Elevating and Amusement Devices Safety Program	Ref. No.: 306 / 24 – r1
ADVISORY	Date: July 10, 2024

Subject: Federal Elevator LULA – Verification of correct shackle assembly
Distribution: Posted on TSSA website

Federal Elevator Safety Bulletin

Bulletin Date/Revision: June.21, 2024/Rev. 1

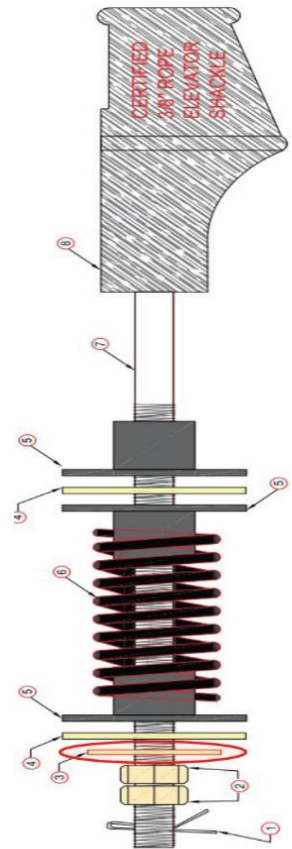
Upon investigation, it was determined that a washer was missing from the installed assembly (see item 3 in the adjacent representation). The affected shackle assembly is the EMCO 100 installed on Federal Elevator LULAs with serial numbers F-8200 and under.

All EMCO 100 shackle assemblies on Federal Elevator LULA elevators shall have a 1/2" washer at minimum (see no. 3 in the drawing). These washers are part of the original kit for these shackles. Contractors shall verify that the 1/2" washer is present and that the shackle is installed correctly per the Federal Elevator drawing. If the washer is missing or incorrectly installed, retrofit the shackle with a 1/2" washer as per Federal Elevator specifications (contact Federal Elevator for washers). Alternatively, use a 1/2" SAE Grade 5, ASTM F346 hardened steel washer.

The shackle and the spring (see item 6) should also be visually inspected for any signs of wear and should be replaced accordingly.

Figure 1: Federal Elevator Shackle (Item #3 is the NEW washer to be added)

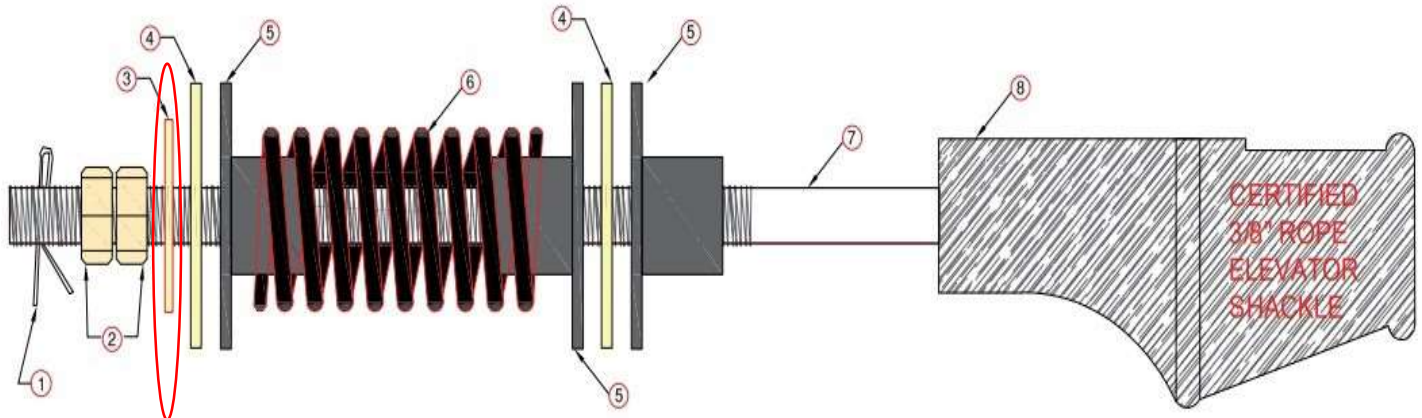
Some shackles may be incorrectly installed and could be missing a ½” washer. The correct shackle assembly is as per figure 1 – (see Item 3 for correct placement of the ½” washer)

13. Additional ½” flat washer to be added between 5/8” washer and ½” nuts. See figure 1 below.
14. Re-install shackle onto bottom sling channel.
15. Reconnects brake rod and hinge plate.
